**CITY OF WEST DES MOINES
BOARD OF ADJUSTMENT COMMUNICATION**

Item: Johanningmeier Variance, 720 Maple Street – Approval of a sixteen foot (16’) variance from the twenty foot (20’) front yard building setback requirement to allow placement of an existing residential structure that is to be moved from its current location onto the subject property – Renae Johanningmeier – VAR-003552-2017

RE: 720 Maple Street – Johannngmeier Variance
 Submitted July 13, 2017 (Project # VAR-003552-2017)

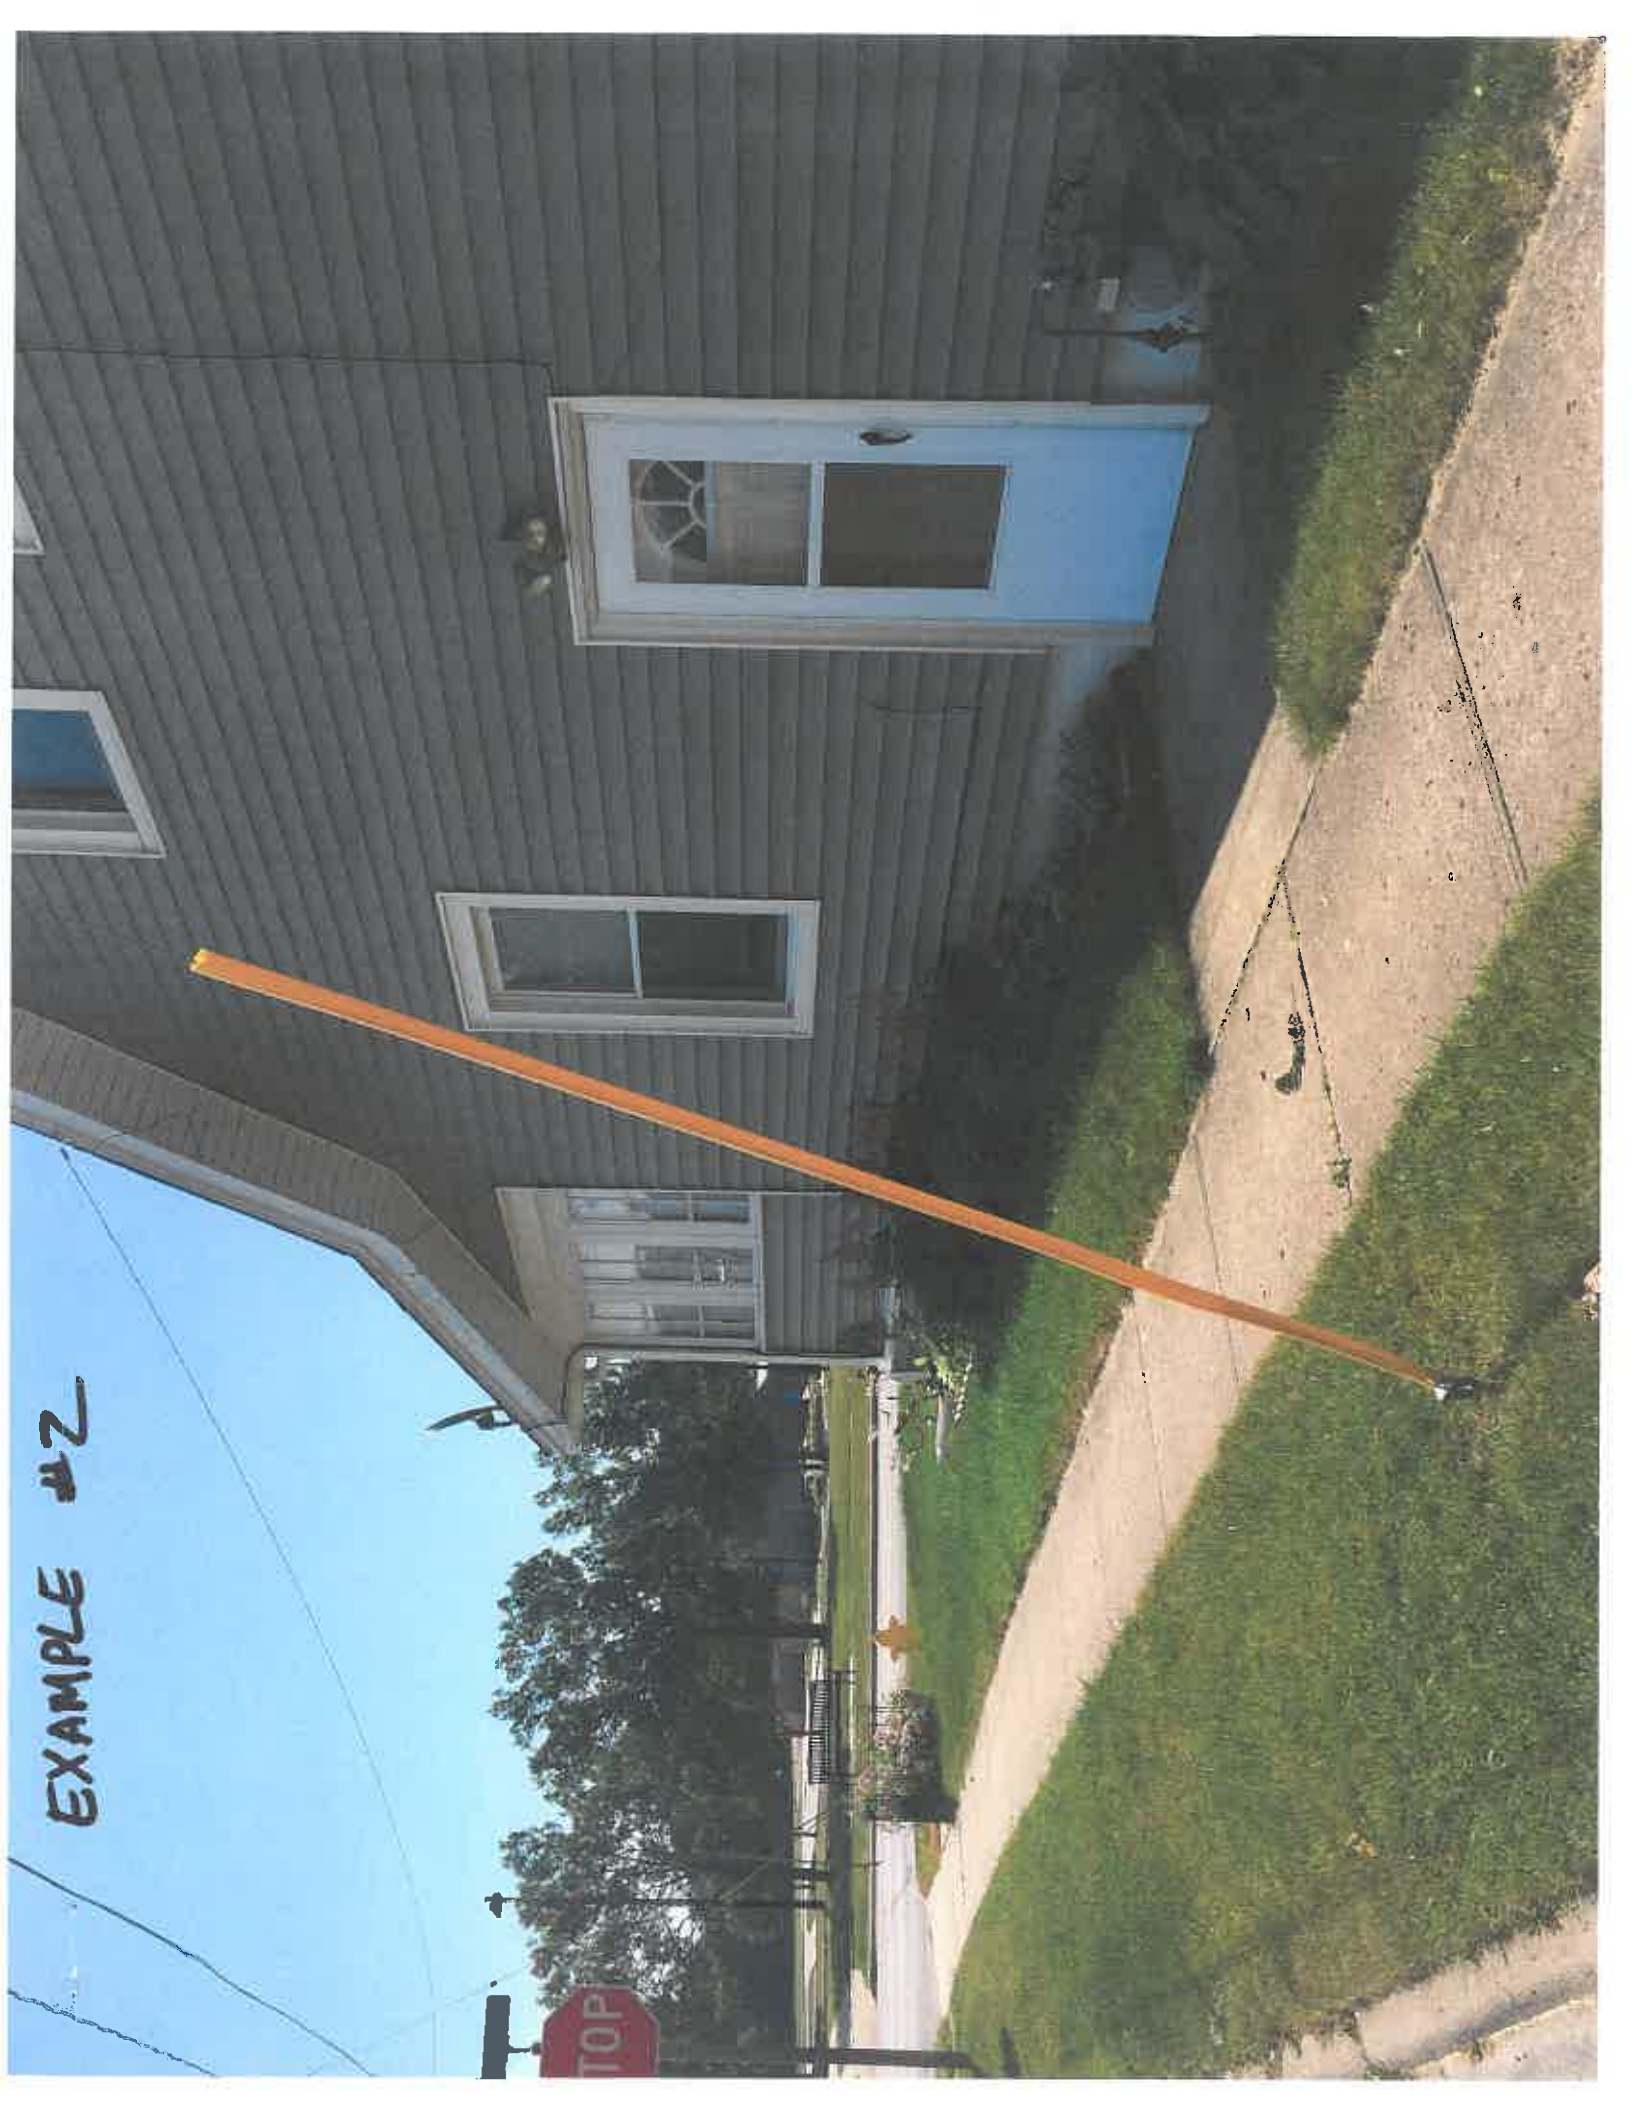
- *Example #1:* located at 545 8th street. A beautiful large stucco home. Variance is 5'5" from sidewalk to foundation and bump out cantilever is 18 inches, which leaves house 3'11" from sidewalk.
- *Example #2:* located at 740 8th Street (directly across from Hillside School). Variance is 6'1" from sidewalk to foundation.
- *Example #3:* located at 644 7th Street. Variance is 7'1" from the sidewalk and steps are less than 24 inches from the sidewalk.
- *Example #4:* located at 134 6th Street. Although this newly built building is zoned commercial (Polk County Community Center), it is directly next to the sidewalk, and yet the visual impact on Maple Street is very positive (also , the WDM Human Services building located at 139 6th Street).
